This Service Information bulletin supersedes SI B63 06 11 dated **January 2012**.

Recall Campaign 11V-438: Repair Ground Cable for Rear Light Lamps (Side Panel)

E46/4 (3 Series Sedan) produced from 9/1/01 to 02/01/05

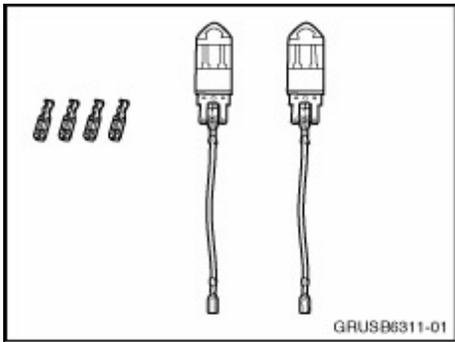
NEW If the lights within either tail lamp assembly **are not** functioning, inspect the wire harness connectors (left side connector X319 and right side connector X318). If thermal damage is found, then:

NEW Replace **the 8-pin connector socket housing and all 7-pin connectors** for the

malfunctioning side(s) only.

NEW Remove the socket housing (1) (X338 and/or X339): Refer to ISTA (Integrated Service Technical Application) Repair Instructions **REP 63 21 055** "Replace the socket housing for the left-hand or right-hand rear light (side panel)".

NEW Make note of the pin assignments and wire colors. Remove the harness tape about 150 mm from the 8-pin socket housing. Cut the cables off directly flush with the 8-pin socket (connector) housing X319 and/or X318 as needed. Replace the socket housing and all the (7) connector terminals, only for the defective side. Clean the connectors on the light carrier to improve a good contact to the other circuits. Proceed to the next step, # 3.

3. In this step, the repair kit (see diagram) is used.

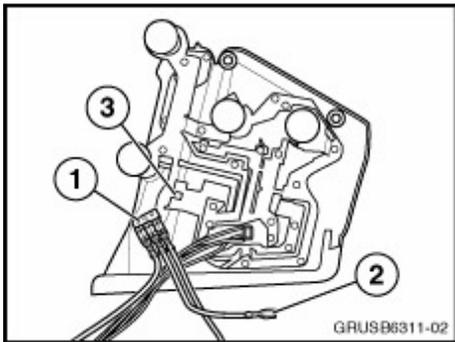
NEW Locate the brown wire (pin #2 for X338/X319 for the left and pin #3 for X339/X318 for the right side), and cut the brown wire approx. 45 mm from the 8-pin connector. Do the below procedure for both sides.

4. Strip both ends of the wire and install two of the supplied female terminals.

5. Connect the two female terminals onto the outer terminals of the supplied comb connector (1).

Insert the fully assembled comb connector into the insulator housing and snap in place.

Install the female terminal end of the comb connector ground wire (2) to the blade terminal of the tail lamp circuit board (3), as shown in the diagram.
